NEW RIVER DAM

PERIODIC INSPECTION
REPORT NO. I
MARCH 1985

TEAM INSPECTION OF NEW RIVER DAM
Periodic Inspection Report No. 1
Dated March 1985

SPD COMMENTS ON
NEW RIVER DAM, PHOENIX, ARIZONA

Photo 15. Downstream view of outlet channel. Note erosion area of type III stone near end of channel. The area has since been repaired by the contractor.

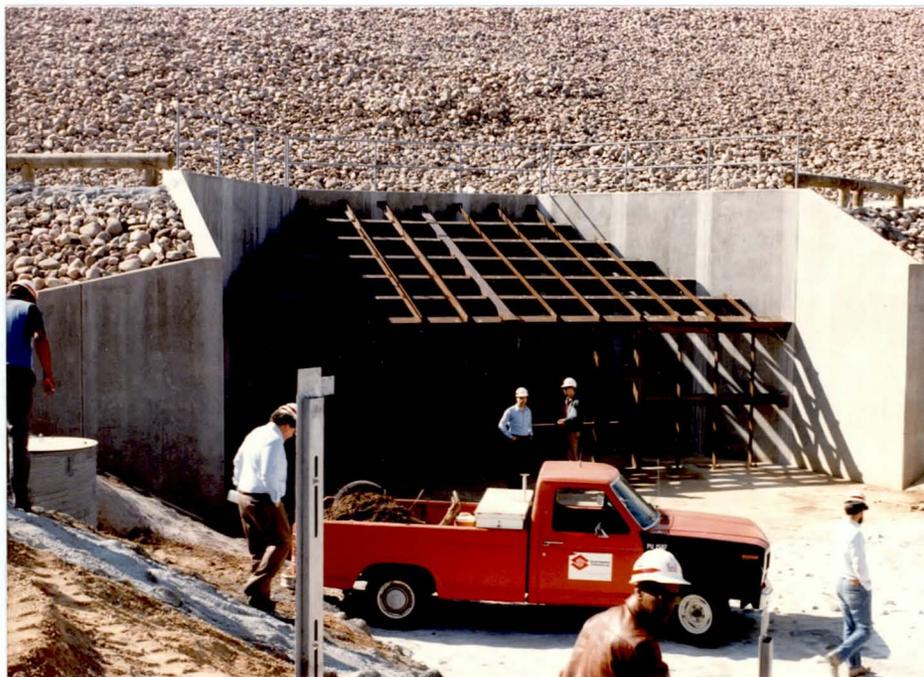
(5) Outlet channel (photo 15). The stone facing on the side slopes and invert of the trapezoidal channel was in good condition. At some localized areas of the outlet channel, the type III stone placed within the channel had been eroded by a flow of about 2 feet in depth.

4. At some localized areas of the outlet channel, the Type III stone (6 inch maximum and 60% to 100% passing 4 inch) placed within the channel had been eroded by a flow of about 2 feet in depth. The progress of erosion should be monitored.

f. The area under the type III stone which was eroded in the outlet channel was considered a localized construction problem and has subsequently been repaired by the contractor. Future flows will be observed to determine the overall performance of the type III stone remaining in the channel.
